Index 550-012 Bridge Fencing (Enclosed)

COMMENTS AND RESPONSES

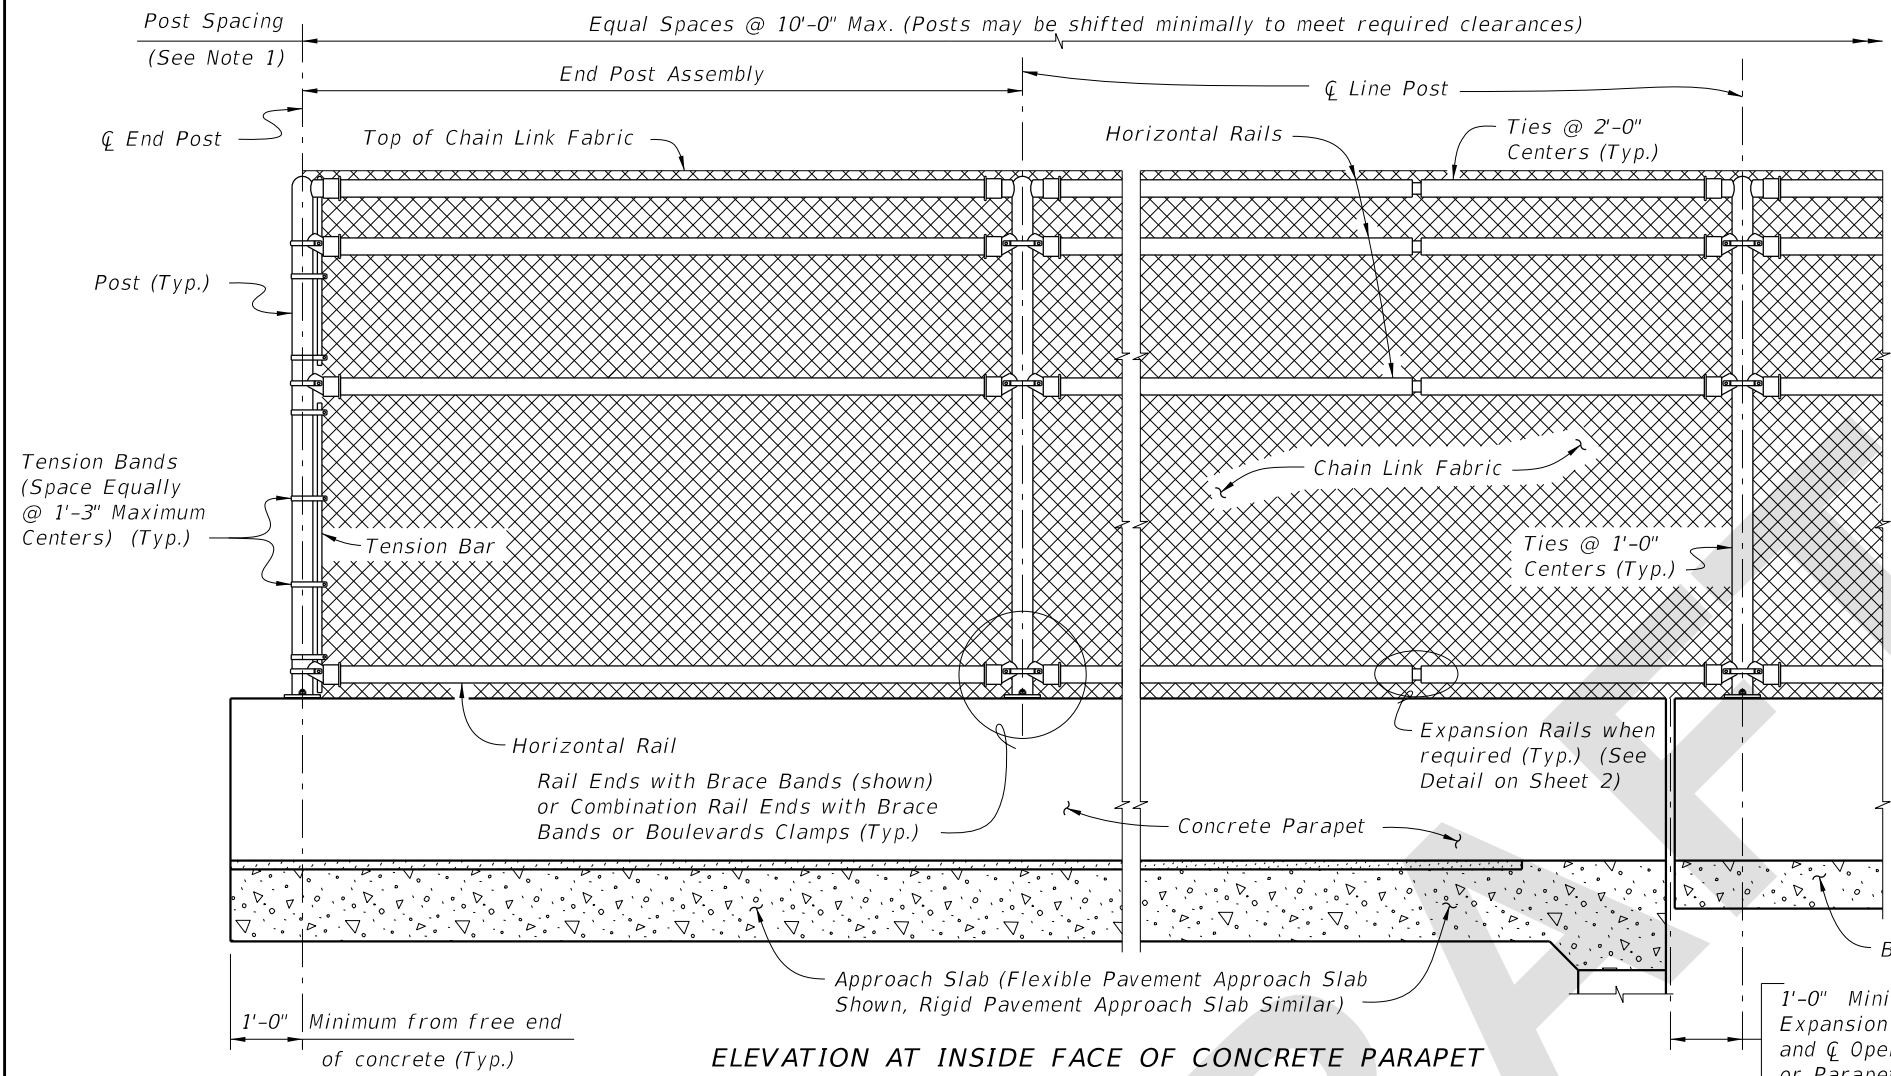
COMMENT: On the righthand side of sheet 1 of 4, please replace the dimension line that was mistakenly deleted

On sheet 4 of 4, please fix the sheet border

RESPONSE: Agreed. Will fix.

CHANGE MADE TO INDEX: Yes, replaced dimension line and fixed border.
